SUBJECT: MILLSTONE POWER STATION, UNIT NO. 3 - ISSUANCE OF RELIEF FROM
CODE REQUIREMENTS (TAC NO. MC8609)

SAFETY EVALUATION BY THE OFFICE OF NUCLEAR REACTOR REGULATION

RELATED TO RELIEF FROM ASME CODE REQUIREMENTS

MILLSTONE POWER STATION, UNIT NO. 3

Figure 1 - MPS3 Typical Weld Overlay Repair Configuration

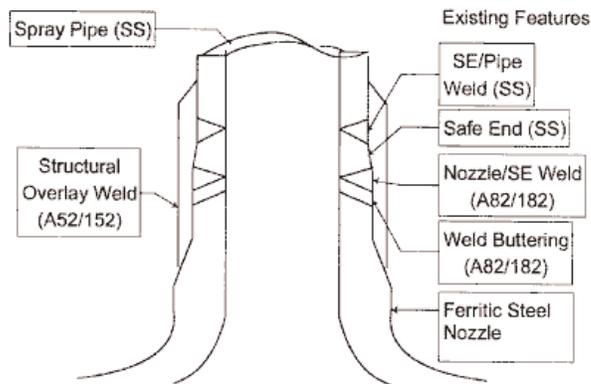
A full structural weld overlay repair is proposed for the pressurizer spray nozzle to safe end HSS dissimilar metal weld (Weld No. 03-X-5641-E-T) with unacceptable indications in the existing Alloy 82/182 weld material. The application of this relief request will include the adjacent acceptable stainless steel safe end to pipe weld (Weld No. RCS-517-FW-12). For (Weld No. 03-X-5641-E-T) the nozzle material is ferritic steel (P3). The pipe is austenitic stainless steel (P8). The existing weld filler material is Alloy 82/182 (F43 equivalent to P43). The overlay will be designed as a full structural overlay in accordance with ASME Section XI Code Case N-504-2 and Nonmandatory Appendix Q (Reference 3). The temper bead welding technique will be implemented in accordance with ASME Section XI Code Case N-638-1 (Reference 4) for that portion of the overlay applied over the ferritic base material for which the Construction Code requires post-weld heat treatment. Temperature monitoring requirements contained within this Code Case will be performed using contact pyrometers in lieu of thermocouples required by IWA-4610(a) of the ASME Code, Section XI 1998 Edition with no Addenda (Reference 1). This full structural weld overlay satisfies all the structural design requirements of the pipe as if the pipe were not there. As shown in Figure 1 below, this structural weld overlay (weld reinforcement) will completely cover the existing Alloy 82/182 weld metal and will extend onto the ferritic and austenitic stainless steel material on each end of the weld, including the adjacent acceptable weld (Weld No. RCS-517-FW-12). Although the weld overlay extends the full 360° around the nozzle, only half is shown in Figure 1 for clarity.
